Public Meeting on Reg Guide 1.9 Rev. 5

August 11, 2021

Figure 1
IEEE Std 387-2017

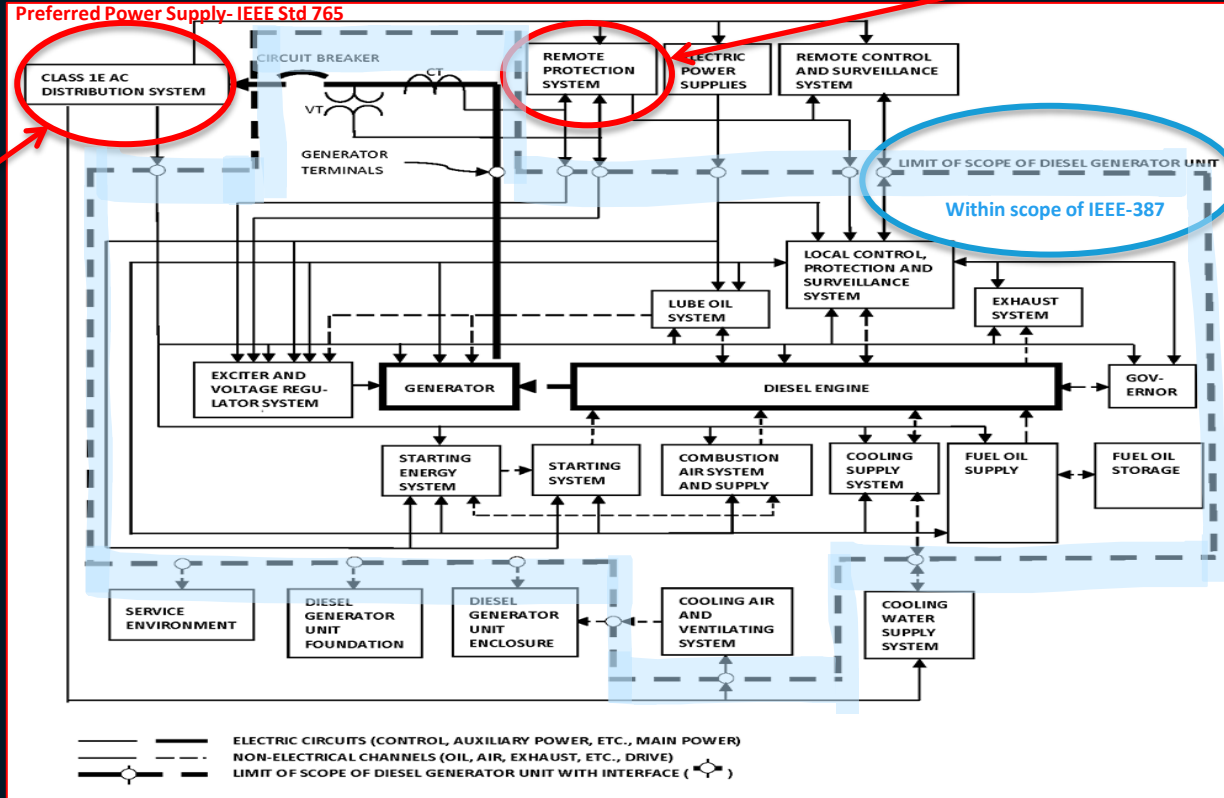
More appropriate to IEEE Std 308 and IEEE Std 741

More appropriate to IEEE Std 308

- Any **design** associated with the detection and protection from a degraded ***preferred power supply*** should be considered part of the “*Remote Protection System*” per Figure 1 of IEEE Std 387-2017 and as such is outside the scope of IEEE Std 387

- The appropriate standards for “*Remote Protection System*” would be IEEE Std 308 and IEEE Std 741
 - The appropriate standard for the ***preferred power supply*** would be IEEE Std 765

- The EDG responding to an accident, loss of offsite power, or both (**signal**) while the EDG is in test mode and paralleled to the grid, is an example of a protection signal that originates **outside** of the EDG scope “*Remote Protection System*” per Figure 1

- IEEE Std 387-2017 principal design criteria is to ensure that the design of the EDG will respond to a valid external signal, but it is not within the scope of IEEE 387 to design these **Remote Protection Systems**

- Remove the proposed addition of Position C.2.3 to supplement IEEE Std 387-2017, Clause 4.4, Table 1
